Informal document **GRSP-51-39**

(51st GRSP, 21 – 25 May 2012,
agenda item 20)

Japanese Proposal for the New Regulation

JASIC / Japan

Problem of the Test Procedure

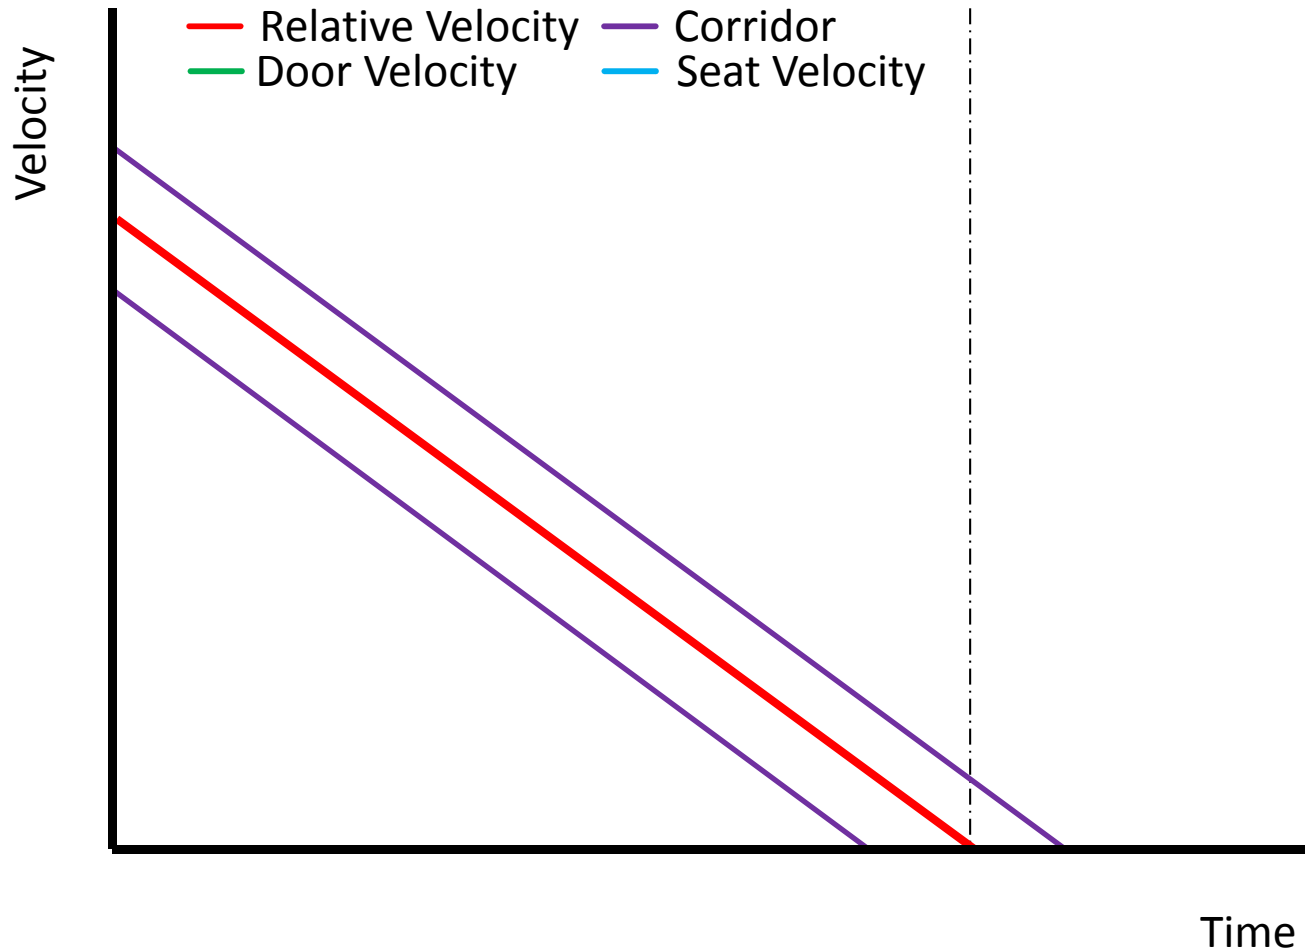
The current draft regulation that defines solely relative velocity allows various test conditions to be set.

Problem of the Test Procedure

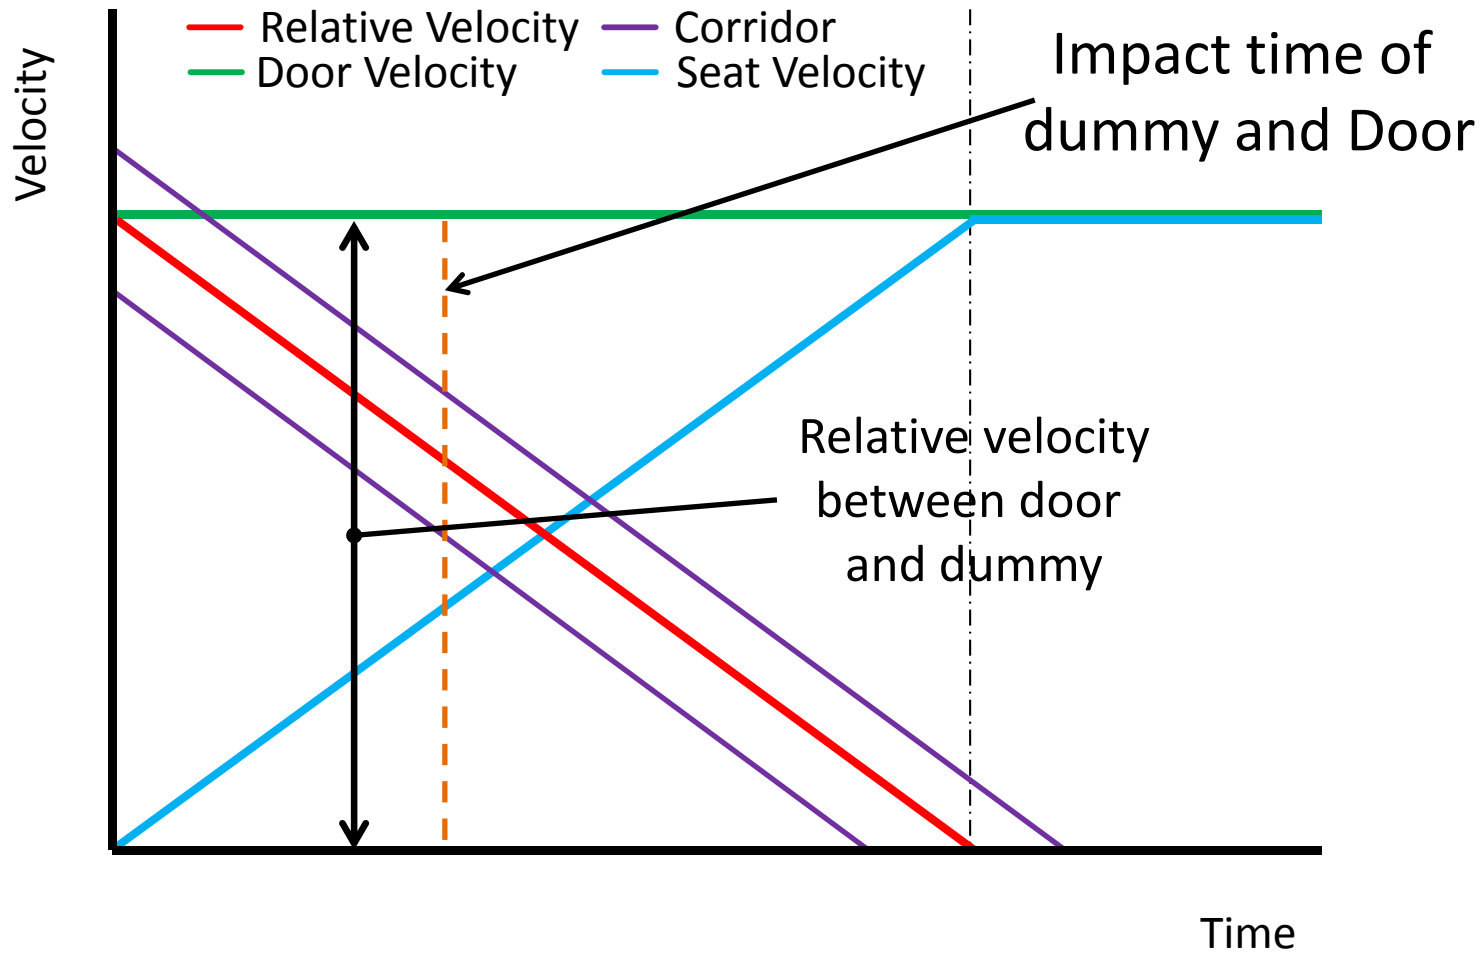
The door speed is constant and the seat is moved rapidly
(Test A condition)

Problem of the Test Procedure

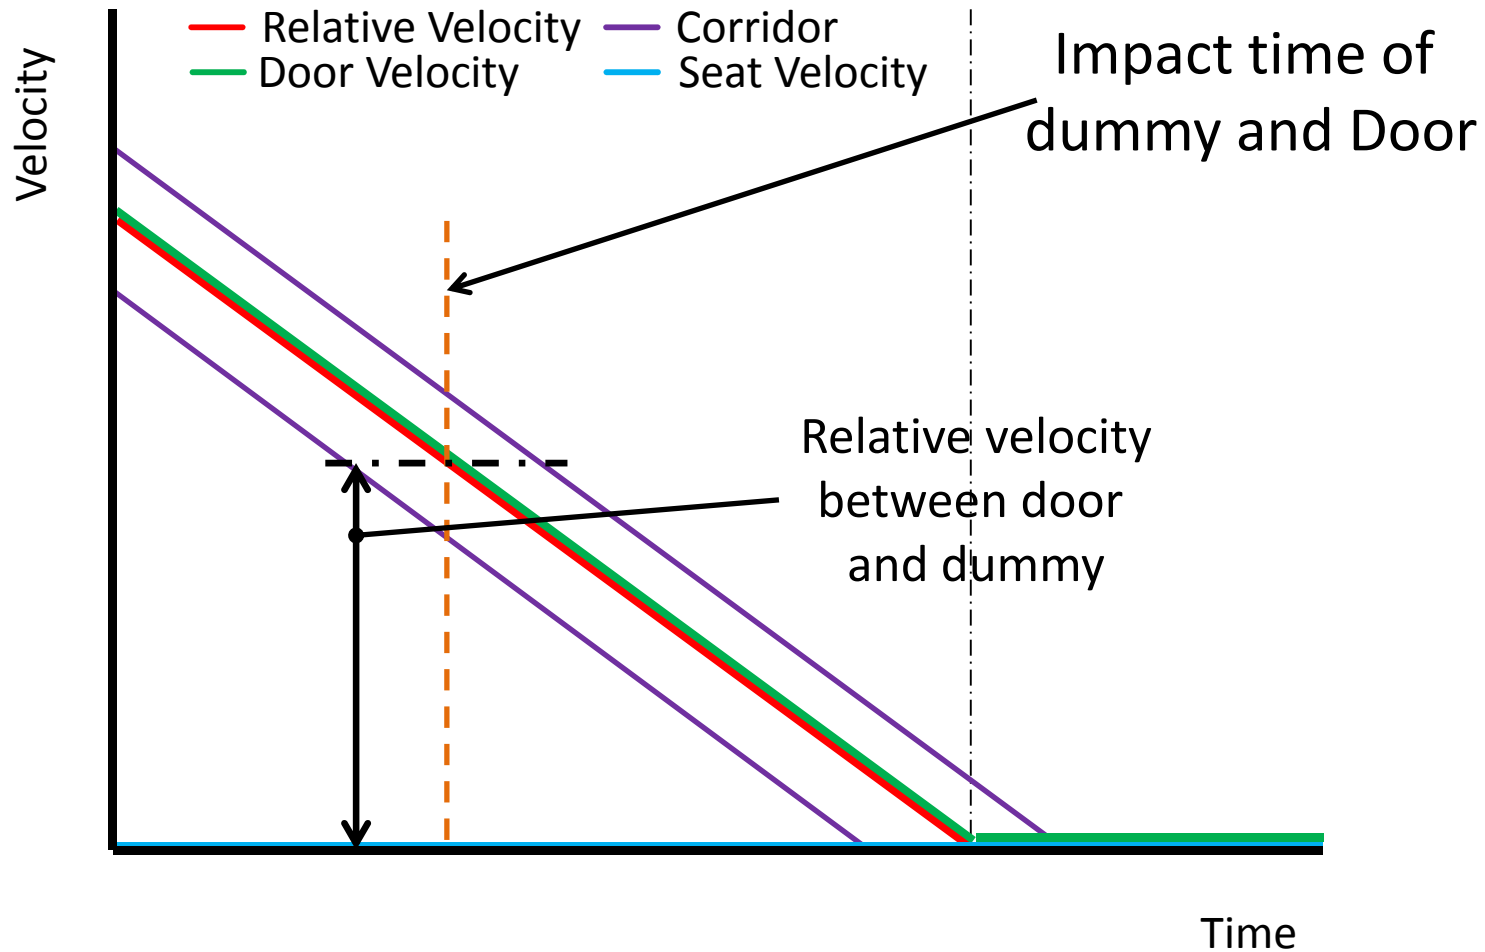
The door speed decreases and the seat stops
(Test B condition)

Problem of the Test Procedure

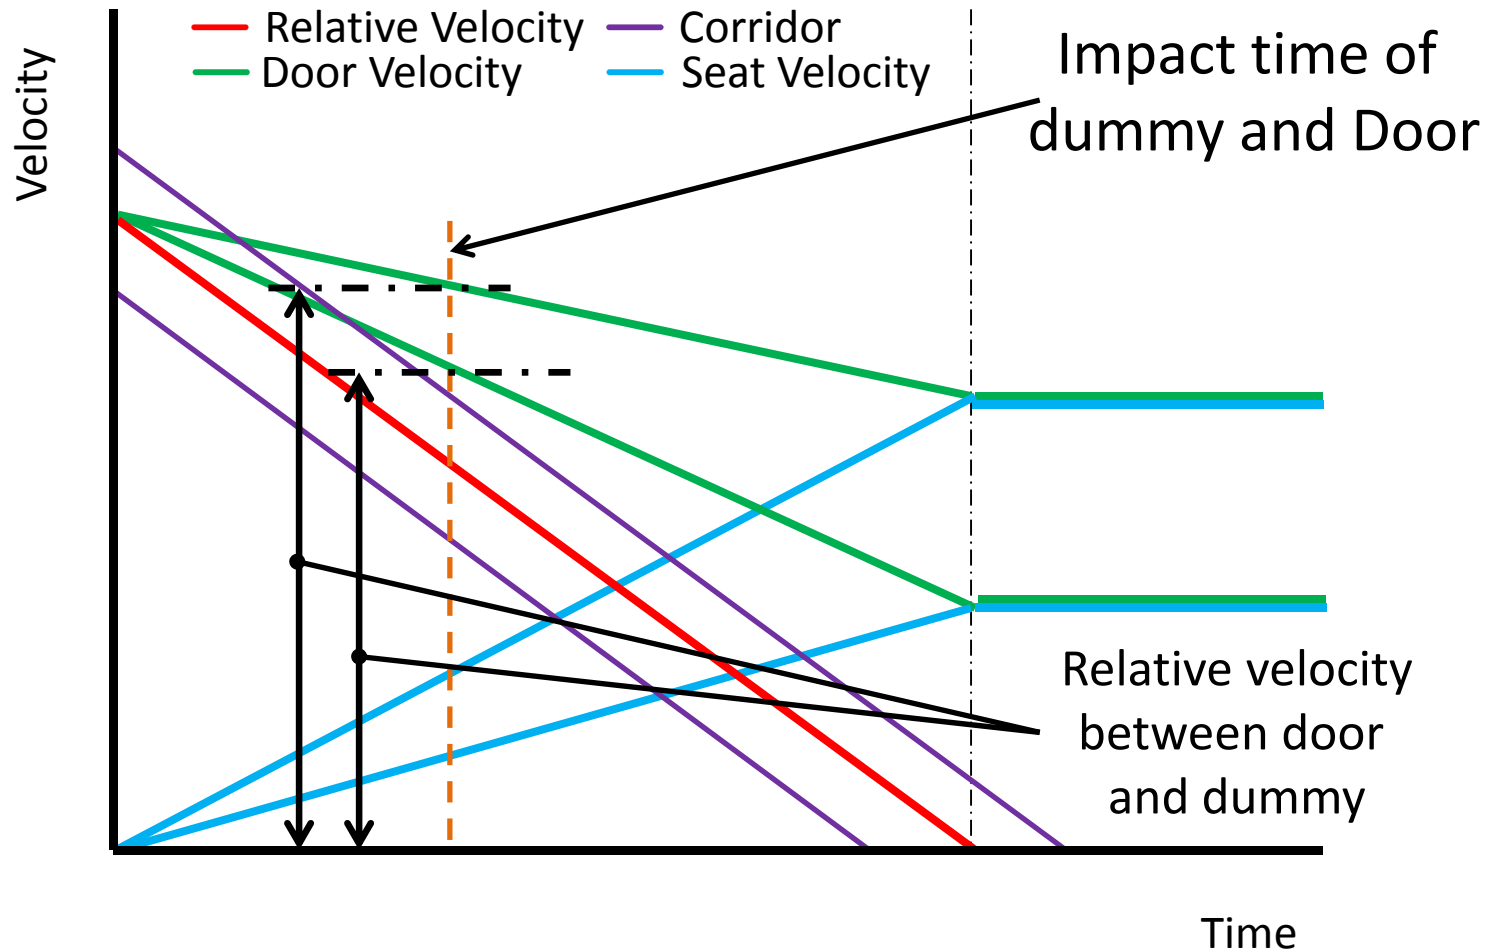
The door speed decreases and the seat moves
(Various conditions between Test A and B)

Problem of the Test Procedure in Deceleration Type Sled

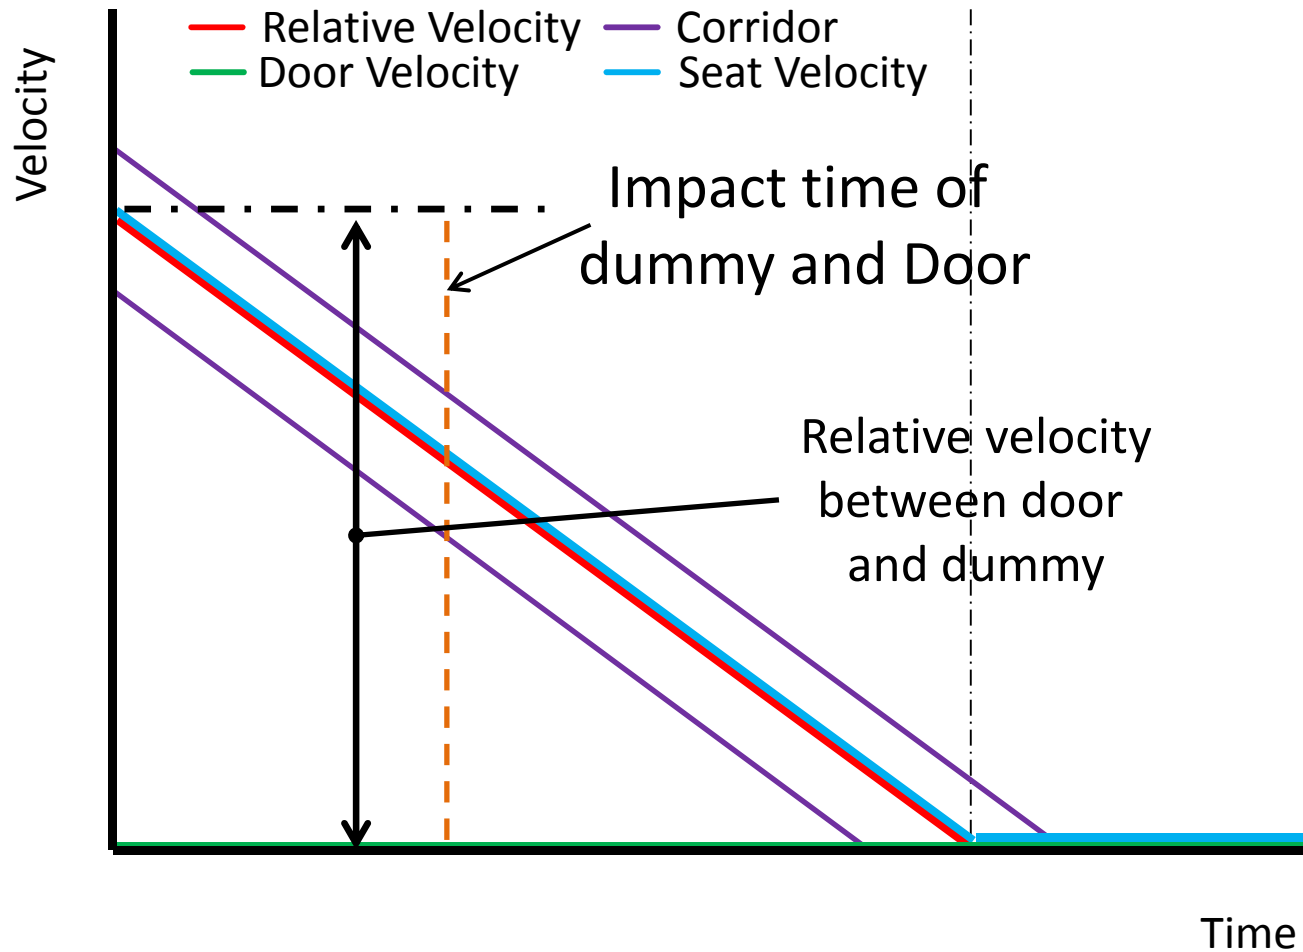
The door stops and the seat speed decreases in corridor
(Same condition as Test A)

Problem of the Test Procedure in Deceleration Type Sled

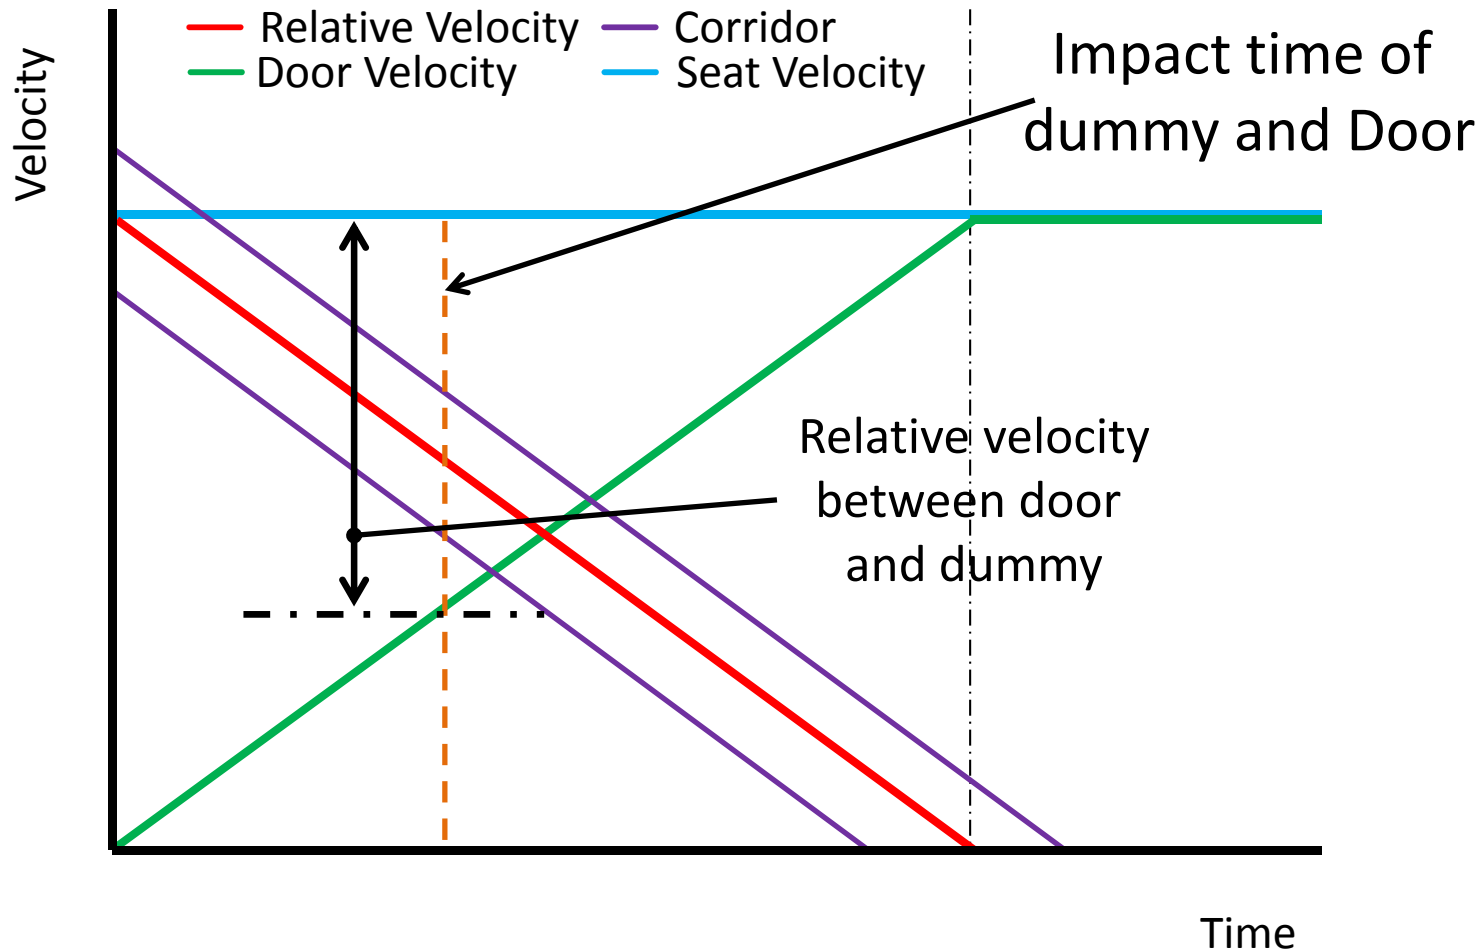
The door speed increases and the seat speed is constant
(Same condition as Test B)

Problem of the Test Procedure in Deceleration Type Sled

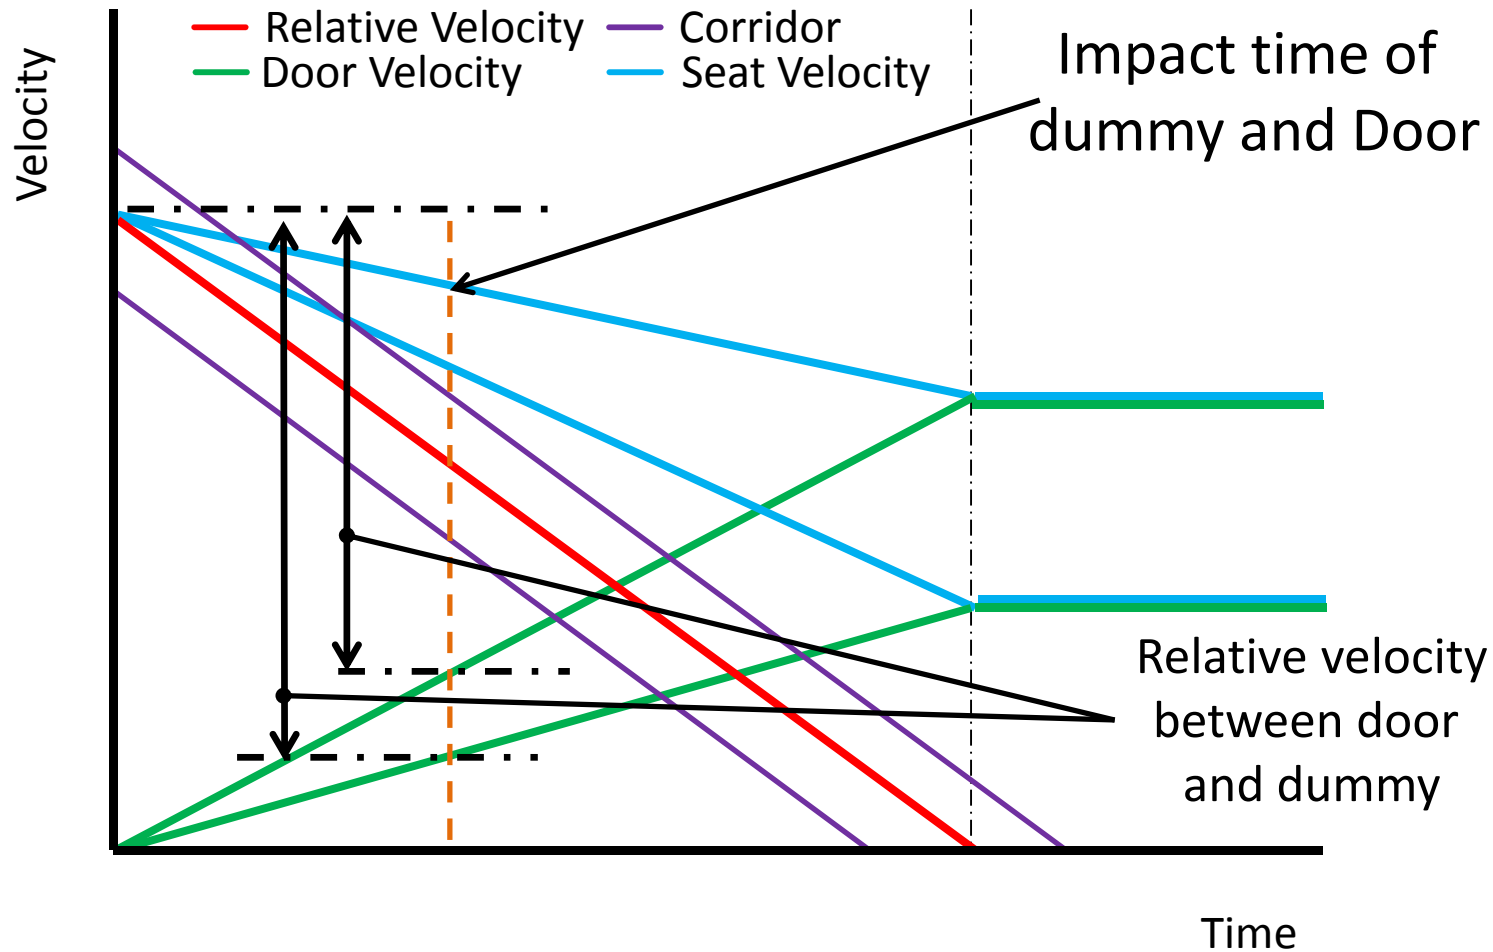
The door speed increases and the seat speed decreases
(Various conditions)

Japanese Proposal

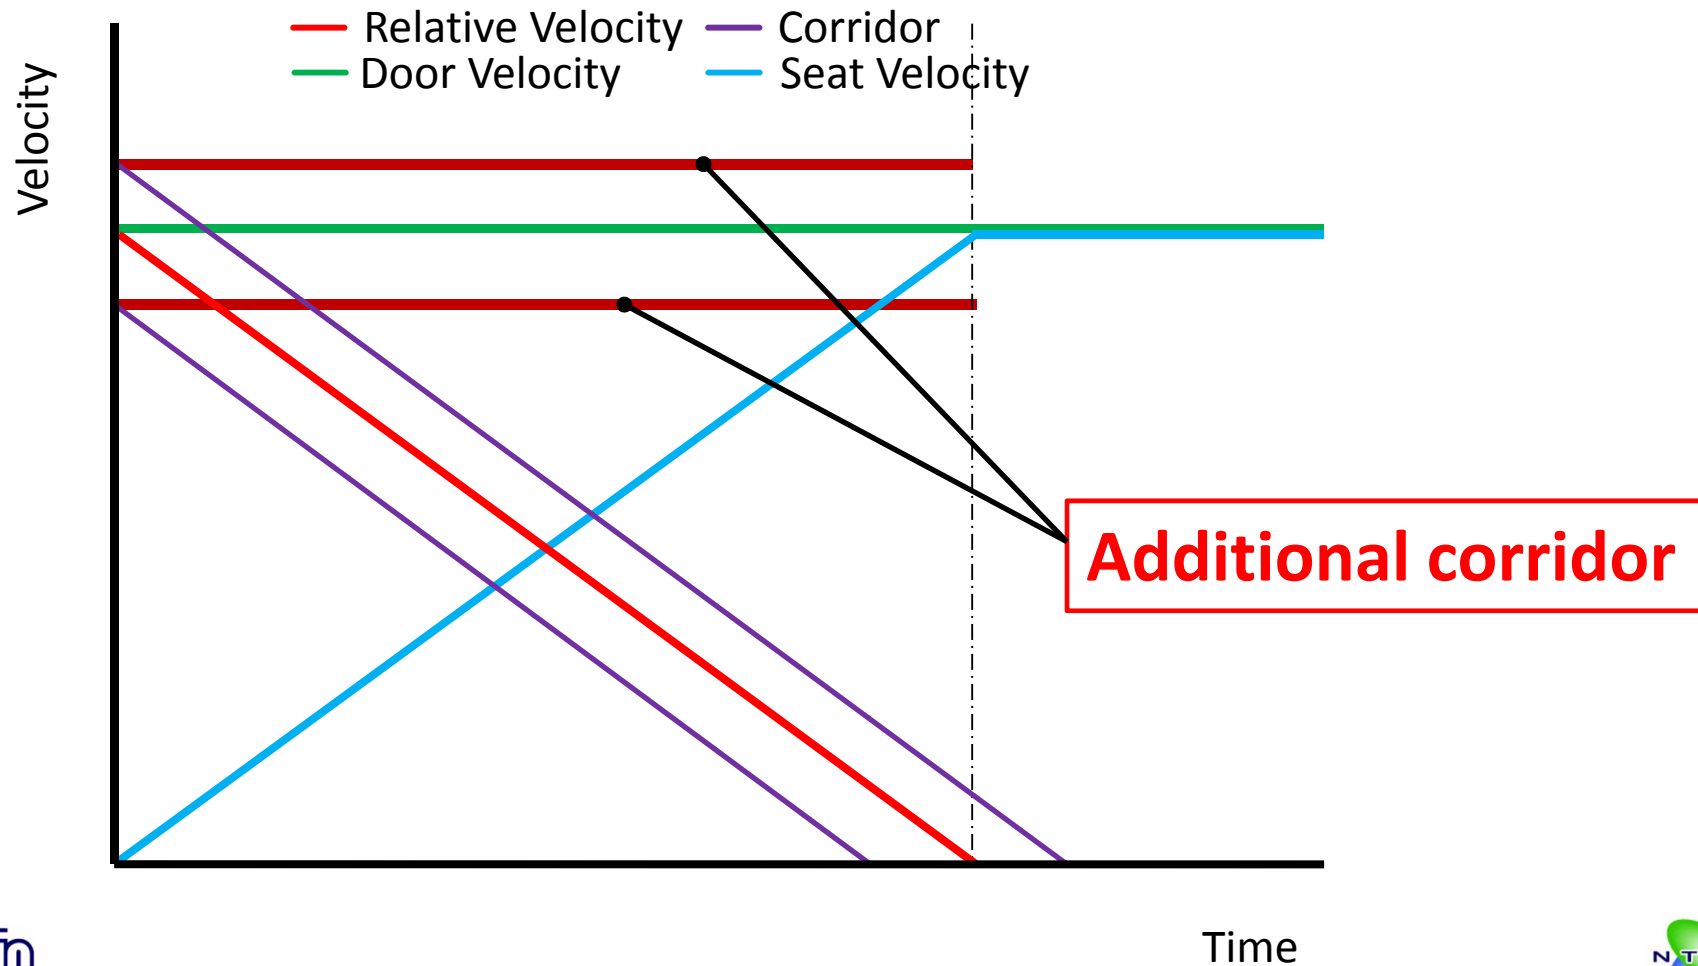
Additional conditions are needed for the CRS side impact test procedure of the new regulation to make the conditions the same in various tests.

Add door ground velocity to define one test condition

- In a test which the door is moving at $T = 0\text{ms}$, (i) the door ground velocity shall be between $[6.375\text{m/s}]$ and $[7.25\text{m/s}]$ at least the time when the door intrusion is maximum, and (ii) dummy is stayed at $T = 0\text{ms}$.
- In a test which the door is stayed at $T = 0\text{ms}$, (i) the door shall be fixed, and (ii) the dummy's [chest] ground velocity shall be between $[6.375\text{m/s}]$ and $[7.25\text{m/s}]$ at $T = 0\text{ms}$.
